Lower Thames Crossing

Comments on Modelling Submissions at D6A

*Prepared by Simon Tucker BSc (Hons) MCIHT
on behalf of DP World London Gateway*

13th November 2023
SJT/20491-05 Comments on Modelling
Submissions at D6a

Plate B.6 2030 PM plots VISSIM delays hard coded into SATURN, Thurrock

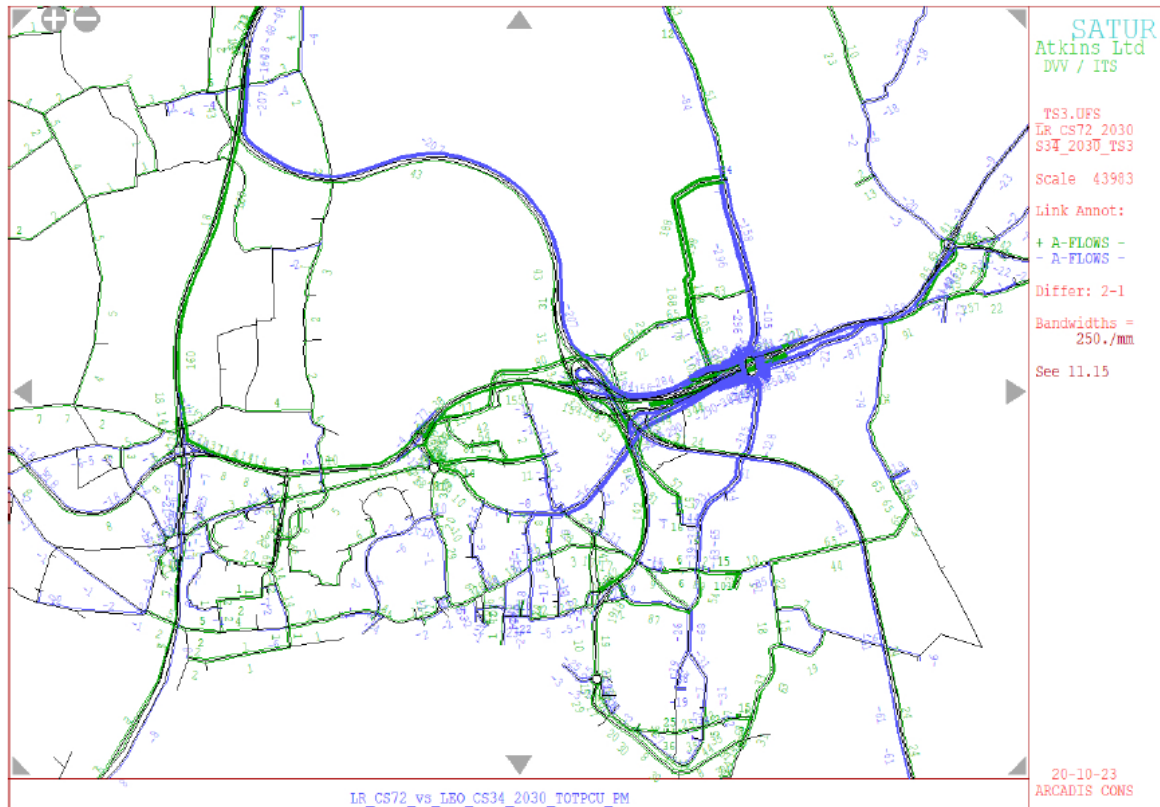
2.6 Plate B6 shows significant reductions in traffic flows using Orsett Cock. Because the models have been subject to Variable Demand modelling, the changes in flow could be for the following reasons (in order of the likely impact):

- Re-routing;
- Trip re-distribution (change in trip origin and/or destination);
- Mode shift; and
- Trip suppression.

2.7 Assuming that re-routing is the key changing factor, these flows appear to be reassigning to either J30 or to local roads around Thurrock including most substantially Orsett Village itself. The reassignment back to J30 is of concern given the purported benefits provided to DPWLG in terms of journey times (as set out in Appendices B and C of the TA provide at D4) which were dependent on the removal of congestion issues at J30 (see also Appendix A2 of Appendix E of 9.53 at Deadline 2 (REP2-050)).
